**Buildings to be Planned for Use by Persons with a Disability  
Regulation 72 of Building (Planning) Regulations  
Design Manual: Barrier Free Access 2008**

## **Amendments to the Design Manual: Barrier Free Access 2008**

### **( November 2012 )**

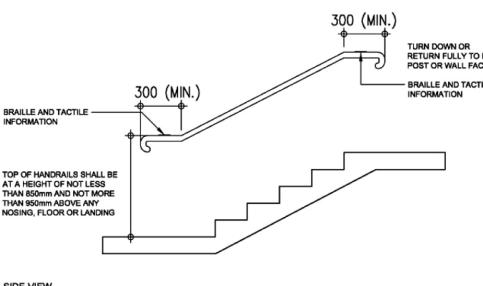
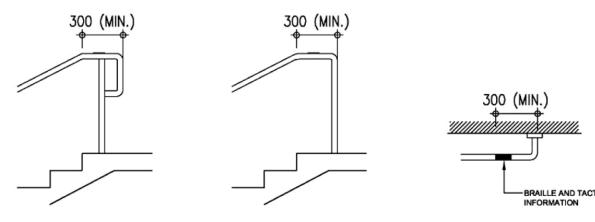
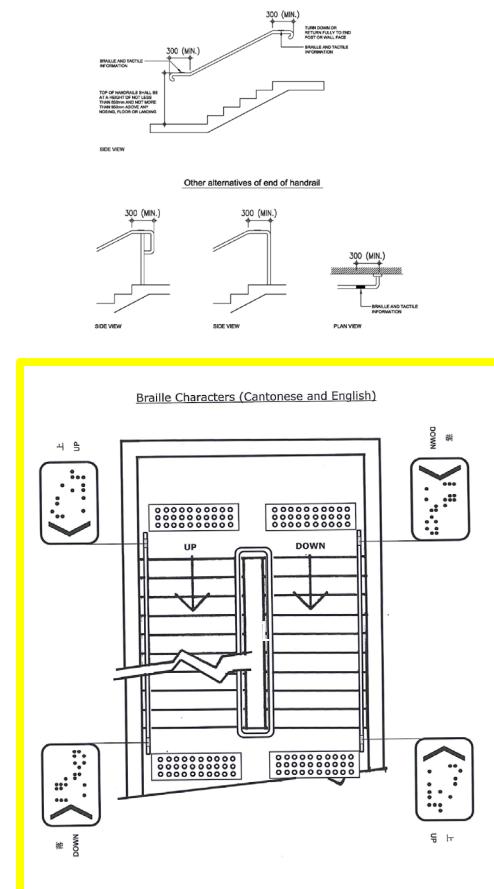
Item	2008 version	Amendments
1. Figure 16A (Paragraph 30 in Division 8)@	 <p><b>SIDE VIEW</b></p> <p><b>Other alternatives of end of handrail</b></p>  <p><b>PLAN VIEW</b></p>  <p><b>Braille Characters</b></p>  <p>*ALL DIMENSIONS ARE IN mm</p> <p><b>Figure 16A – Handrails of Staircase</b></p>	 <p><b>Braille Characters (Cantonese and English)</b></p> <p>*ALL DIMENSIONS ARE IN mm</p> <p><b>Figure 16A – Handrails of Staircase</b></p>

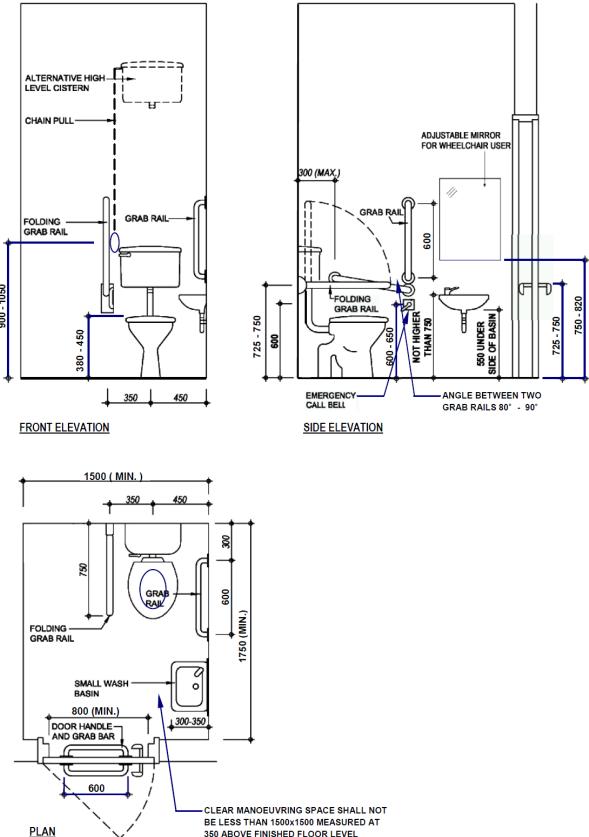
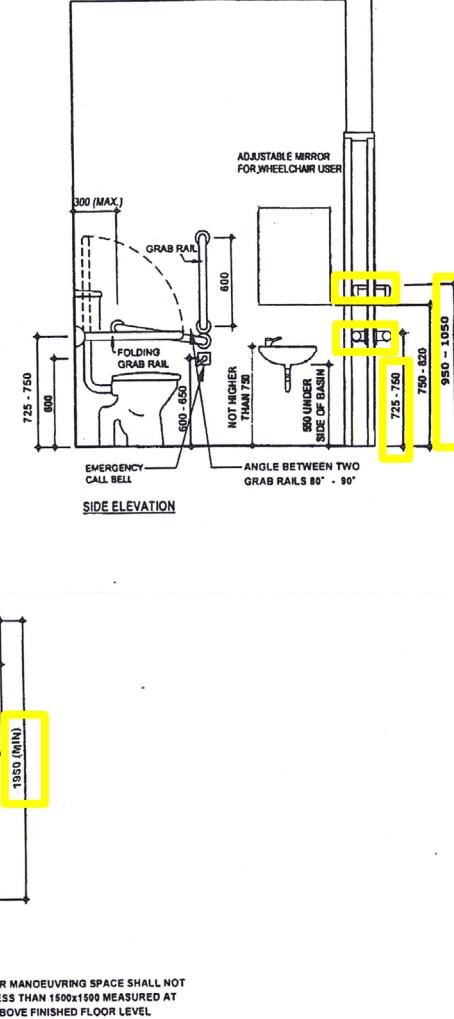
Item	2008 version	Amendments
3. Figure 24 (Division 11)@*	 <p><b>Front Elevation:</b></p> <ul style="list-style-type: none"> <li>ALTERNATIVE HIGH LEVEL CISTERN</li> <li>CHAIN PULL</li> <li>FOLDING GRAB RAIL</li> <li>GRAB RAIL</li> <li>900 - 1050 mm height</li> <li>350 - 450 mm side clearance</li> <li>450 mm side clearance</li> </ul> <p><b>Side Elevation:</b></p> <ul style="list-style-type: none"> <li>300 (MAX.) mm height</li> <li>600 mm height</li> <li>NOT HIGHER THAN 650 mm height</li> <li>600 UNDER SIDE OF BASIN</li> <li>725 - 750 mm height</li> <li>750 - 820 mm height</li> <li>ANGLE BETWEEN TWO GRAB RAILS 80° - 90°</li> <li>EMERGENCY CALL BELL</li> <li>ADJUSTABLE MIRROR FOR WHEELCHAIR USER</li> </ul> <p><b>Plan:</b></p> <ul style="list-style-type: none"> <li>1500 (MIN.) mm width</li> <li>350 mm side clearance</li> <li>450 mm side clearance</li> <li>750 mm side clearance</li> <li>600 mm side clearance</li> <li>600 mm side clearance</li> <li>800 (MIN.) mm door handle and grab bar distance</li> <li>300-350 mm door handle and grab bar distance</li> <li>200 mm side clearance</li> <li>1750 (MIN.) mm width</li> <li>600 mm height</li> <li>300 mm height</li> <li>CLEAR MANOEUVRING SPACE SHALL NOT BE LESS THAN 1500x1500 MEASURED AT 350 ABOVE FINISHED FLOOR LEVEL</li> <li>FOLDING GRAB RAIL</li> <li>GRAB RAIL</li> <li>SMALL WASH BASIN</li> <li>DOOR HANDLE AND GRAB BAR</li> </ul> <p><b>Notes:</b></p> <ul style="list-style-type: none"> <li>*ALL DIMENSIONS ARE IN mm</li> <li>DIMENSIONS PRINTED IN BOLD FORM DENOTE OBLIGATORY REQUIREMENT</li> <li>DIMENSIONS PRINTED IN ITALIC FORM DENOTE RECOMMENDED REQUIREMENT</li> <li>(Opposite - Handed Layout is Acceptable)</li> </ul> <p><b>Figure 24 – Accessible Toilet</b></p>	 <p><b>Front Elevation:</b></p> <p><b>Side Elevation:</b></p> <p><b>Plan:</b></p> <p><b>Notes:</b></p> <ul style="list-style-type: none"> <li>*ALL DIMENSIONS ARE IN mm</li> <li>DIMENSIONS PRINTED IN BOLD FORM DENOTE OBLIGATORY REQUIREMENT</li> <li>DIMENSIONS PRINTED IN ITALIC FORM DENOTE RECOMMENDED REQUIREMENT</li> <li>(Opposite - Handed Layout is Acceptable)</li> </ul> <p><b>Figure 24 – Accessible Toilet</b></p>

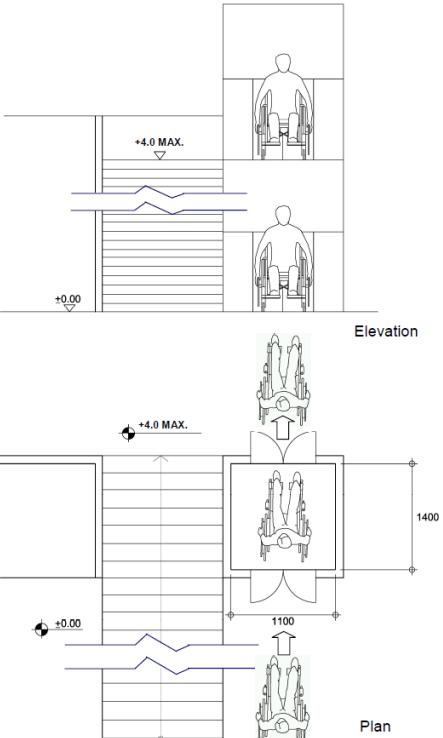
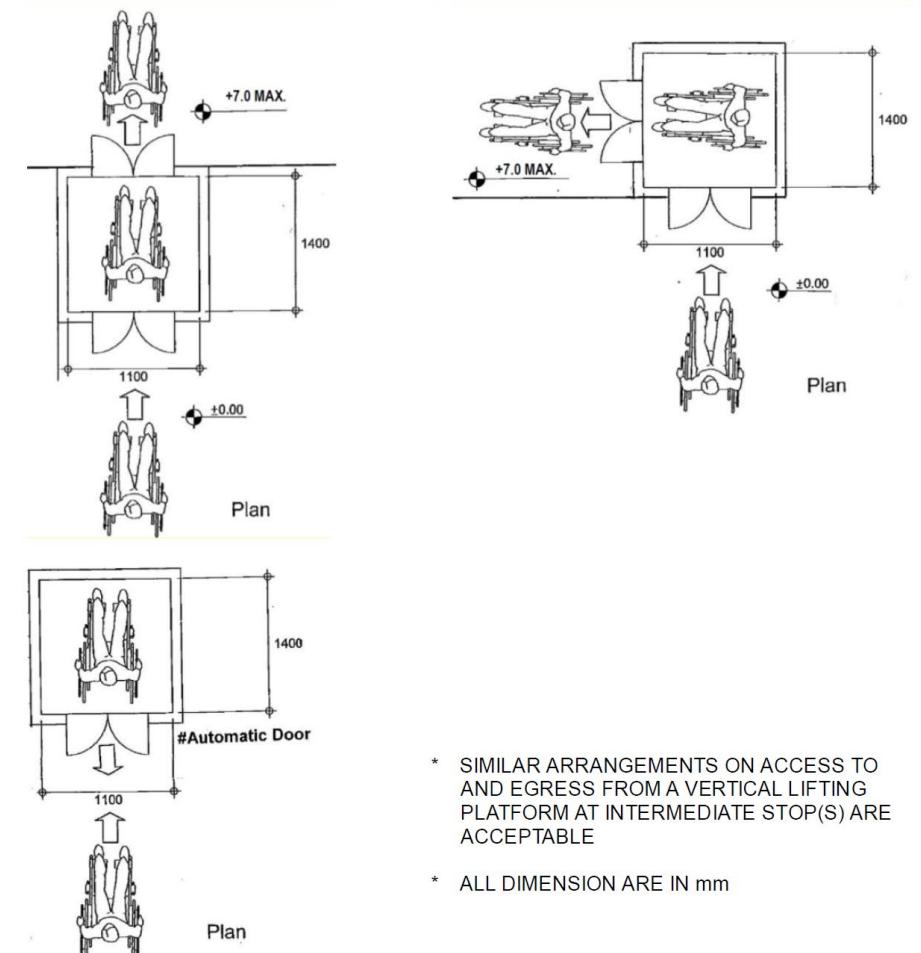
Item	2008 version	Amendments
5. Figure 45	 <p>Figure 45 – Vertical Lifting Platform</p>	 <ul style="list-style-type: none"> <li>* SIMILAR ARRANGEMENTS ON ACCESS TO AND EGRESS FROM A VERTICAL LIFTING PLATFORM AT INTERMEDIATE STOP(S) ARE ACCEPTABLE</li> <li>* ALL DIMENSION ARE IN mm</li> </ul> <p>Figure 45 – Vertical Lifting Platform</p>

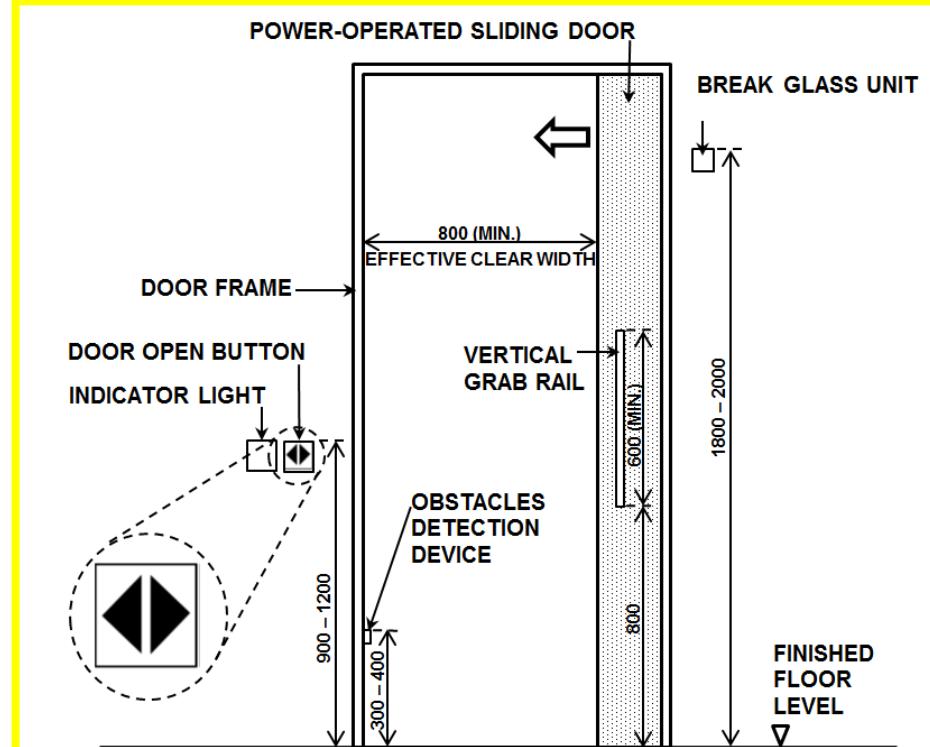
Item	2008 version	Amendments
2. Figure 32@	 <p>(THIS MAP IS DESIGNED FOR PERSONS WITH VISUAL IMPAIRMENT.)</p> <p>(此圖為視覺受損人士而設。)</p> <p>Note: → The 2m and 5m as shown on the Map are hypothetical figures only. They shall be subject to actual site condition.</p> <p>Braille information:</p>	 <p>五樓換換走火圖 Tactile Fire Exit Map of 5/F</p> <p>Legend</p> <ul style="list-style-type: none"> <li>Base Plate (square)</li> <li>Other Tactile Features (+4mm) (triangle)</li> <li>Emergency Exit (+4mm) (star)</li> </ul> <p>You Are Here</p> <p>緊急出口 Emergency Exit</p> <p>升降機 Lift</p> <p>走火路線 Escape Route</p> <p>樓梯 Staircase</p> <p>斜道 Ramp</p> <p>房門 Doorway</p>

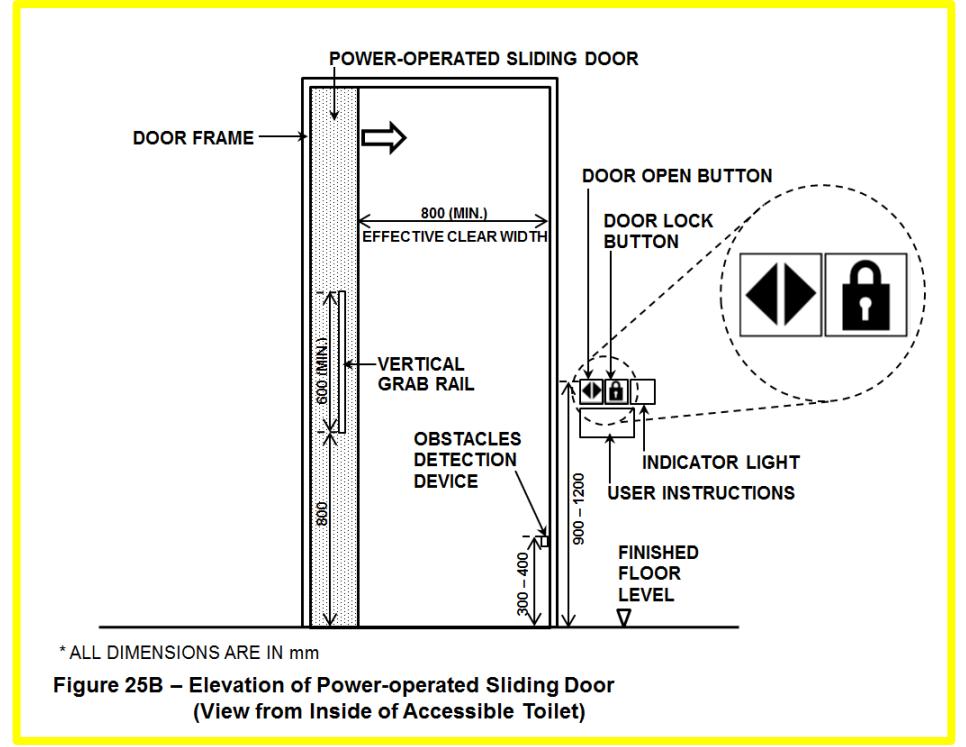
Item	2008 version	Amendments																											
4. Figure 31 in Division 13 of Chapter 4@	 <p>Figure 31 – Specification of Braille Cells</p> <table border="1" data-bbox="422 508 1066 587"> <tbody> <tr> <td>Dot Spacing :</td> <td>2.5 mm</td> <td>Character Spacing :</td> <td>6.5 mm</td> </tr> <tr> <td>Dot Height :</td> <td>0.5 mm</td> <td>Line Spacing :</td> <td>10.0 mm</td> </tr> <tr> <td>Dot base diameter :</td> <td>1.5 mm</td> <td></td> <td></td> </tr> </tbody> </table>	Dot Spacing :	2.5 mm	Character Spacing :	6.5 mm	Dot Height :	0.5 mm	Line Spacing :	10.0 mm	Dot base diameter :	1.5 mm			 <p>(a) BRAILLE CELL</p> <table border="1" data-bbox="1516 500 1808 659"> <tbody> <tr> <td>Dot Spacing</td> <td>:</td> <td>2.5 mm</td> </tr> <tr> <td>Dot Height</td> <td>:</td> <td>0.5 mm</td> </tr> <tr> <td>Dot Base Diameter</td> <td>:</td> <td>1.5 mm</td> </tr> <tr> <td>Character Spacing</td> <td>:</td> <td>6.5 mm</td> </tr> <tr> <td>Line Spacing</td> <td>:</td> <td>10.0 mm</td> </tr> </tbody> </table> <p>(b) TACTILE SIGN</p> <p>RAISED 0.5 MM ABOVE THE WALL / DOOR SURFACE IN CONTRASTING COLOUR WITH WALL / DOOR</p> <p>WHITE FIGURE RAISED 0.5 MM ABOVE THE BACKGROUND IN CONTRASTING COLOUR WITH BACKGROUND</p> <p>200 MM (MIN.)</p> <p>200 MM (MIN.)</p> <p>200 MM (MIN.)</p> <p>Figure 31 – Specifications of Braille Cells and Tactile Signs</p>	Dot Spacing	:	2.5 mm	Dot Height	:	0.5 mm	Dot Base Diameter	:	1.5 mm	Character Spacing	:	6.5 mm	Line Spacing	:	10.0 mm

Dot Spacing :	2.5 mm	Character Spacing :	6.5 mm																										
Dot Height :	0.5 mm	Line Spacing :	10.0 mm																										
Dot base diameter :	1.5 mm																												
Dot Spacing	:	2.5 mm																											
Dot Height	:	0.5 mm																											
Dot Base Diameter	:	1.5 mm																											
Character Spacing	:	6.5 mm																											
Line Spacing	:	10.0 mm

Figure 32A – Example of Braille and Tactile Plan of Toilet and Changing Room

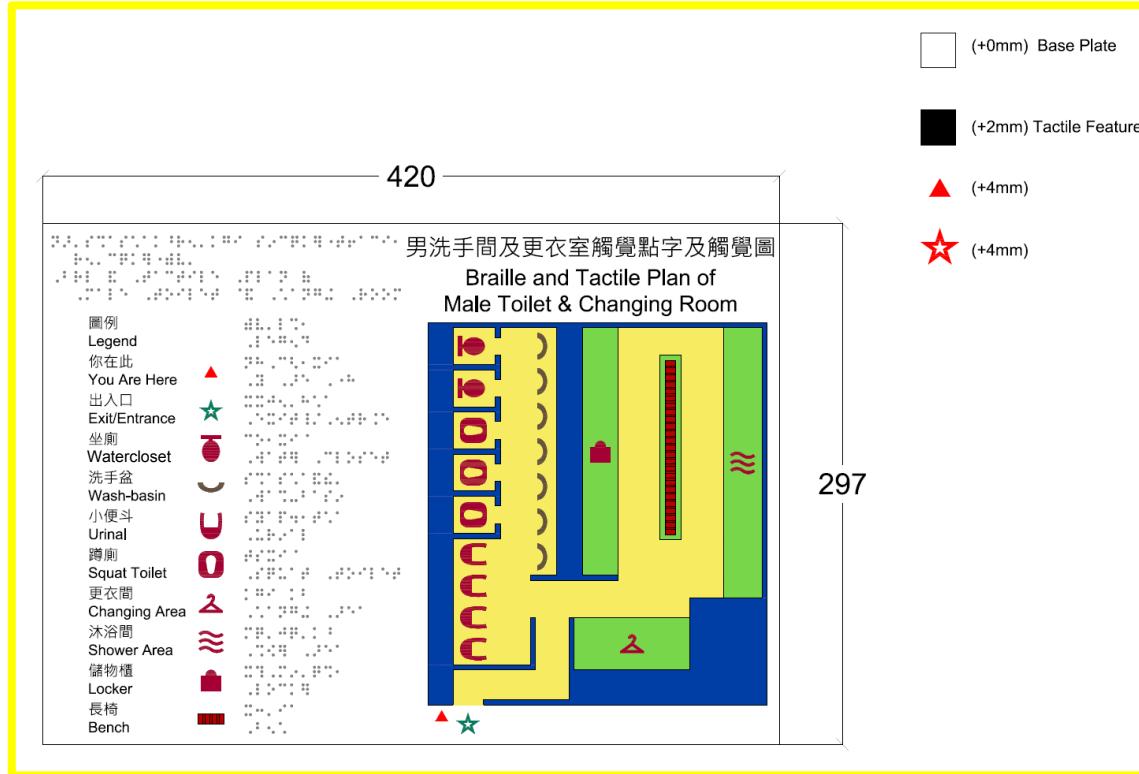
Item	2019 version	Amendments
8. Division 13 of Chapter 4#*	<p><b>BEST PRACTICE SECTION</b></p> <p><b>A. Design Considerations</b></p> <p>Persons with visual impairment may have difficulty in identifying their lockers for public use.</p> <p><b>B. Recommended Design Requirements</b></p> <p>Each locker door in sports complex, public swimming pool complex or public areas should be provided with Braille cells and raised Arabic numerals/characters*. </p> <p>* The locker key holders should be provided with raised Arabic numerals/characters.</p>	<p><b>BEST PRACTICE SECTION</b></p> <p><b>A. Design Considerations</b></p> <p>Persons with visual impairment may have difficulty in identifying their locker for public use, and sanitary fitments in a public toilet or changing room.</p> <p><b>B. Recommended Design Requirements</b></p> <p>(a) Each locker door in a sports complex, public swimming pool complex or public area should be provided with the locker number in Braille and raised Arabic numerals/characters*.</p> <p>* The locker key holders should be provided with raised Arabic numerals/characters.</p> <p>(b) A Braille and tactile plan (see Figure 32A) should be provided for the toilets with five or more waterclosets (urinal in a public male toilet and changing room is regarded as a watercloset for this purpose) in a public toilet/changing room. The plan should be installed on the wall adjacent to the door of the public toilet/changing room, or their entrance if entrance door is not provided. The plan should be placed at 900 mm to 1500 mm above the finished floor level.</p>
